SUBJECT: DONALD C. COOK NUCLEAR PLANT, UNITS 1 AND 2 - ISSUANCE OF  
AMENDMENTS (TAC NOS. MA8893 AND MA8894 )

Amendment No. 249  
License No. DPR-58

Amendment No. 230

SAFETY EVALUATION BY THE OFFICE OF NUCLEAR REACTOR REGULATION  
RELATED TO AMENDMENT NO. 249 TO FACILITY OPERATING LICENSE NO. DPR-58  
AND AMENDMENT NO. 230 TO FACILITY OPERATING LICENSE NO. DPR-74  
INDIANA MICHIGAN POWER COMPANY  
DONALD C. COOK NUCLEAR PLANT, UNITS 1 AND 2  
DOCKET NOS. 50-315 AND 50-316

**Figure 1: Break Exclusion Zones**  
(No Longitudinal or Circumferential Breaks, No Critical Cracks, No Terminal End Breaks)  
Typical for Both Units

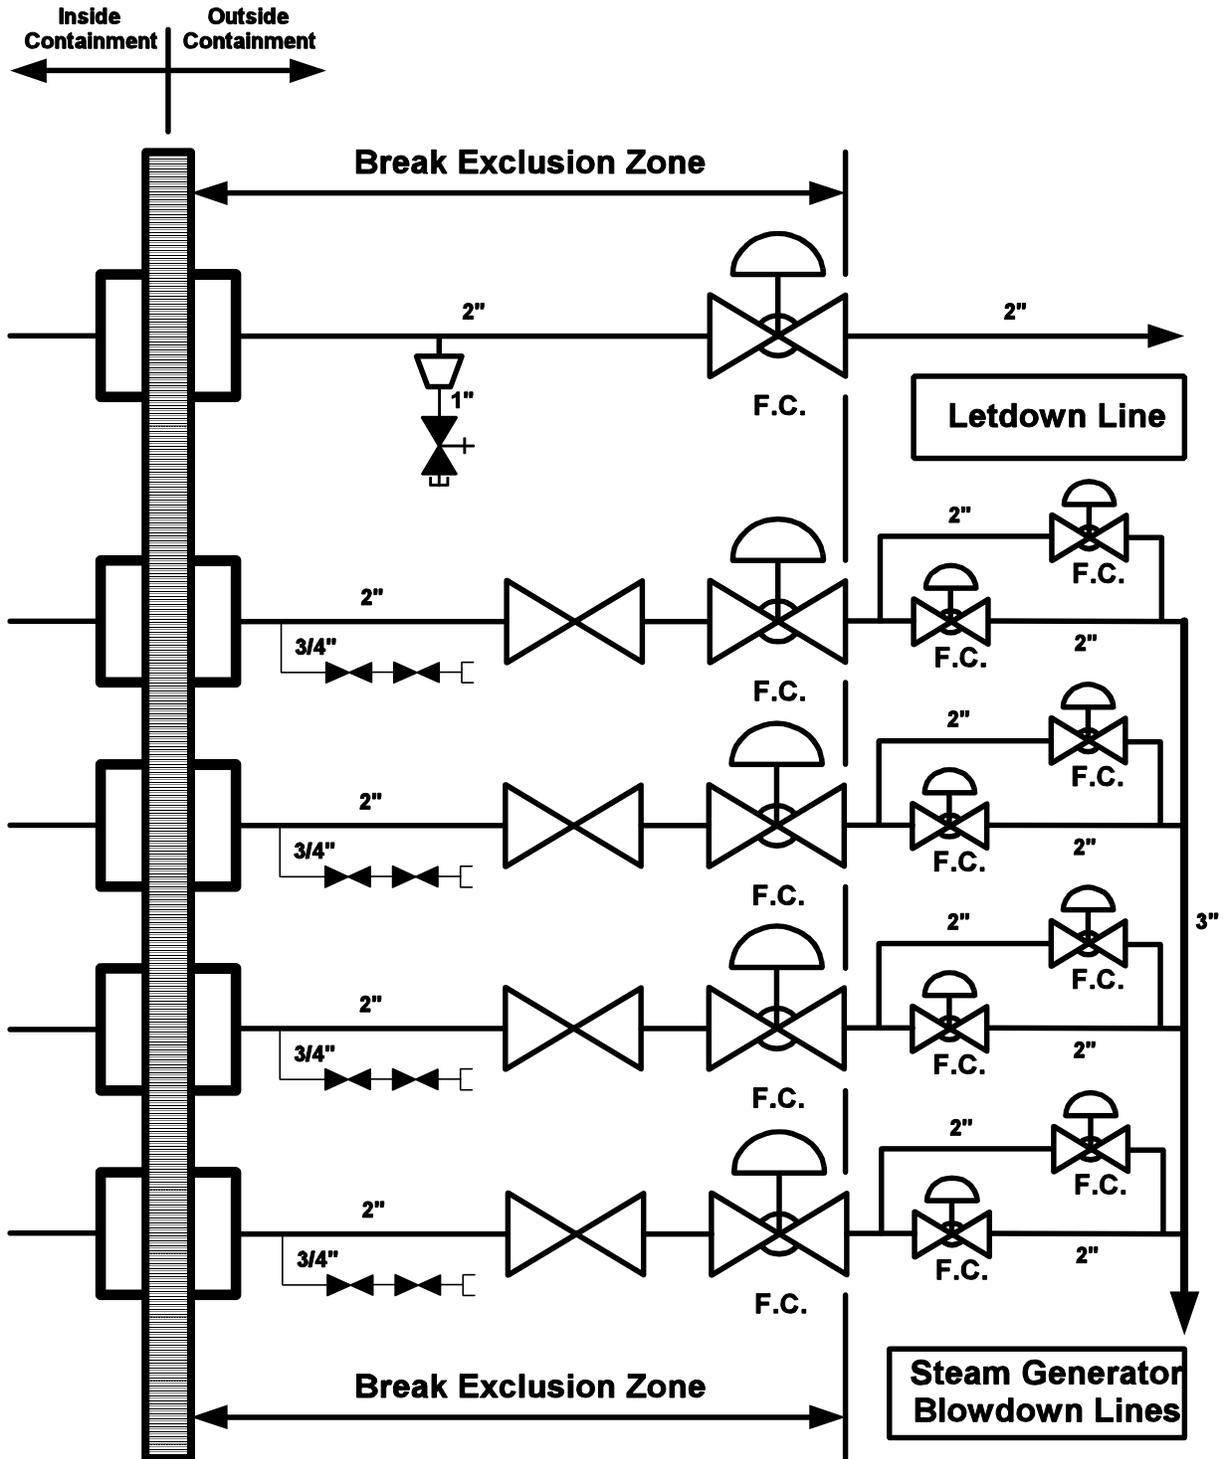
The licensee proposes to apply stress analyses based on USAS B31.1.0-1967, "USA Standard for Pressure Piping, Power Piping," the design code of record for piping at the D. C. Cook plant, for use with SRP 3.6.2, BTP MEB 3-1, Section B.1.b, to establish break exclusion zones. The application of SRP break exclusion zones is requested specifically for the steam generator blowdown (SGBD) and chemical volume control system (CVCS) letdown lines outside containment (see Figure 1).

The SRP Section 3.6.2, BTP MEB 3-1, Section B.1.b, provides for an exclusion from break and crack considerations in the containment penetration area for piping exiting penetrations up to the first isolation valve. As set forth in the SRP, such an exclusion is appropriate only if piping stresses are within specified limits and the piping cannot be adversely impacted by breaks or cracks in other parts of the piping. The licensee proposes to change the licensing and design basis of the piping to preclude the consideration of breaks and cracks in the portions of the SGBD and CVCS letdown lines in the containment penetration areas (designed under the provisions of the Giambusso letter) based on acceptable piping analysis in accordance with USAS B31.1.0-1967. The licensee has performed new detailed stress analyses on the piping in question to verify that the stresses in the piping are within the SRP identified limits. The new calculations identified a number of piping supports that required modifications. Modifications to the piping supports in Unit 2 have been completed and modifications for Unit 1 will be completed prior to Unit 1 entering into operational MODE 3 from its current extended outage.

The SGBD and CVCS letdown piping has been analyzed in accordance with USAS B31.1.0-1967, and support modifications have been performed to ensure that the piping stresses meet the Giambusso break limiting stress criterion of  $0.8(S_h + S_a)$ , which is lower than the SRP limiting stress criterion of  $0.8(1.8S_h + S_a)$ . The symbols  $S_h$  and  $S_a$  represent the allowable stress at maximum (hot) temperature and the allowable stress range for thermal expansion, respectively. The use of this approach to account for the differences between the American Society of Mechanical Engineers (ASME) Code stress methodology used in the SRP and the USAS B31.1.0-1967 stress methodology has been previously reviewed and approved by the NRC for use on USAS B31.1.0-1967 piping located inside containment at Crystal River, Unit 3, by letter dated September 28, 1989. Other requirements for the use of USAS B31.1.0-1967 and MEB 3-1 are also specified in this letter. The licensee stated that the revised analyses

conform with these provisions. The licensee has also evaluated the effects of breaks outside of the containment penetration area and determined that they do not have an adverse impact on the piping within the exclusion zone. The use of this methodology and the modification of the piping supports on the SGBD and CVCS letdown lines ensure a sufficient margin to preclude breaks and cracks in this region of piping. The use of lower limiting stress criteria for the postulation of breaks and cracks in the containment penetration areas of the SGBD and CVCS letdown lines will provide the necessary reasonable assurance for protection from HELB events.

Based on the above, the NRC staff finds the application of stresses calculated in accordance with USAS B31.1.0-1967, in conjunction with SRP BTP MEB 3-1, Section B.1.b, to the portions of SGBD and CVCS piping outside containment located between the containment penetration and the first outboard isolation valve is acceptable.

**Figure 2: Steam Generator Blowdown Line Crack Exclusion**  
(No Critical Cracks)  
Units 1 & 2

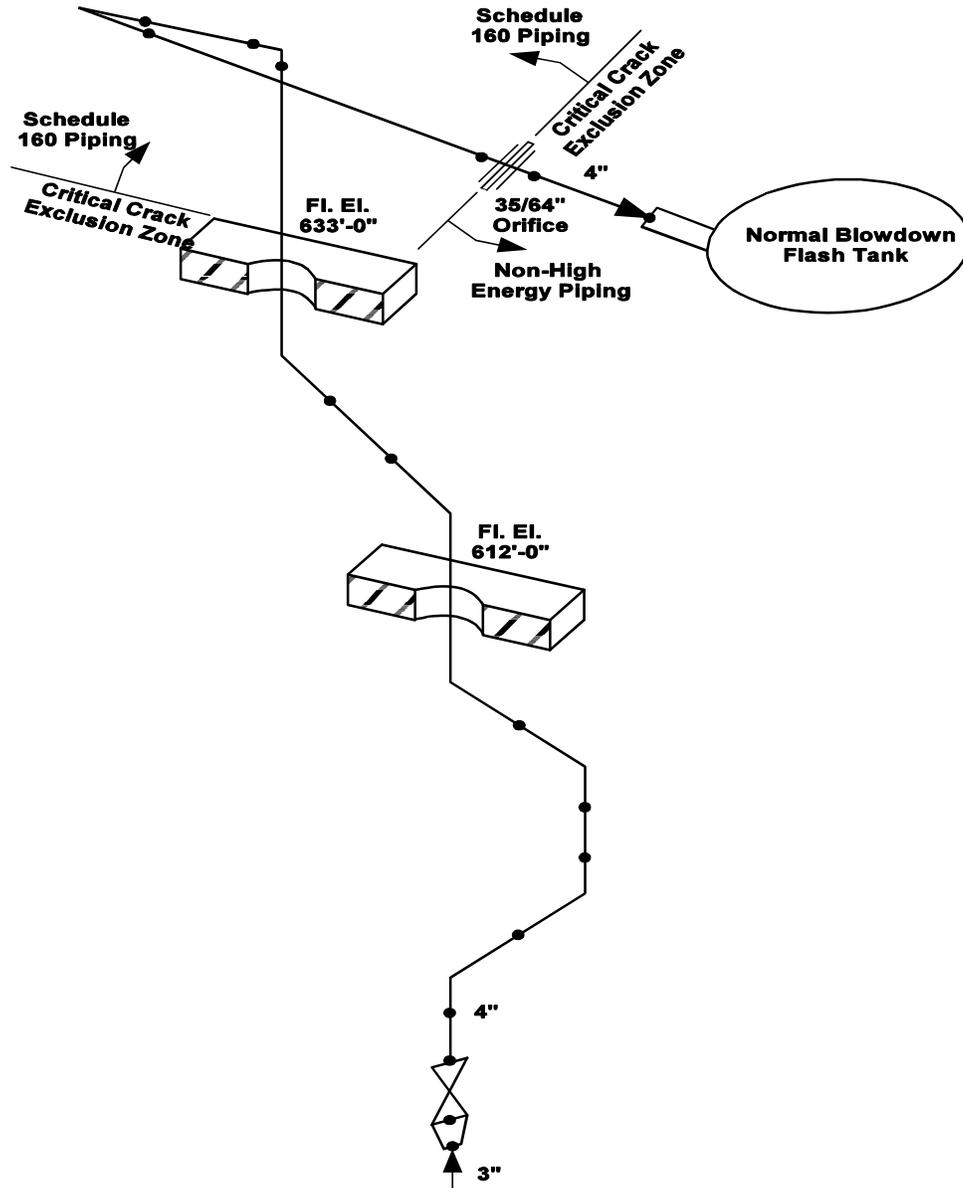
The licensee intends to apply this methodology to a portion of SGBD piping located in the normal flash tank room in Units 1 and 2 (see Figure 2), to eliminate the postulation of a crack in this piping as would be required under the Giambusso letter. This modifies the licensing and design basis for this portion of piping.

The licensee performed new calculations on the piping in question based on USAS B31.1.0-1967 and discovered that approximately 10 feet of piping in Unit 2 needed to be replaced with heavy wall piping, and the piping supports in both Units 1 and 2 needed to be modified, so that the applied stresses met the limiting stress criterion. By letter dated November 13, 2000, the licensee clarified the April 6, 2000, application by indicating that the SRP methodology for crack postulation for the SGBD piping in the normal flash tank room in Unit 1 was required.

The use of piping stresses based on USAS B31.1.0-1967 to predict crack postulation based on the SRP methodology and the limiting stress criterion for cracks stated in the NRC letter September 28, 1989, is acceptable and conservative. This methodology for the postulation of cracks in the SGBD piping in the normal flash tank rooms is conservative and provides the margin to failure, which is inherent in the material properties and allowables of the SGBD piping. The replacement of the normal piping with heavy wall piping in Unit 2, piping support

modifications, in the new stress calculations based on USAS B31.1.0-1967, in conjunction with the conditions and the limiting stress criterion for crack postulation, provides reasonable assurance that the stresses in the SGBD piping are sufficiently low to exclude the SGBD piping from crack formation.

Based on the above, the NRC staff finds the application of stresses calculated in accordance with USAS B31.1.0-1967, in conjunction with SRP BTP MEB 3-1, Section B.1.e, to the portions of the SGBD piping outside containment located in the normal flash tank rooms in Units 1 and 2 is acceptable.
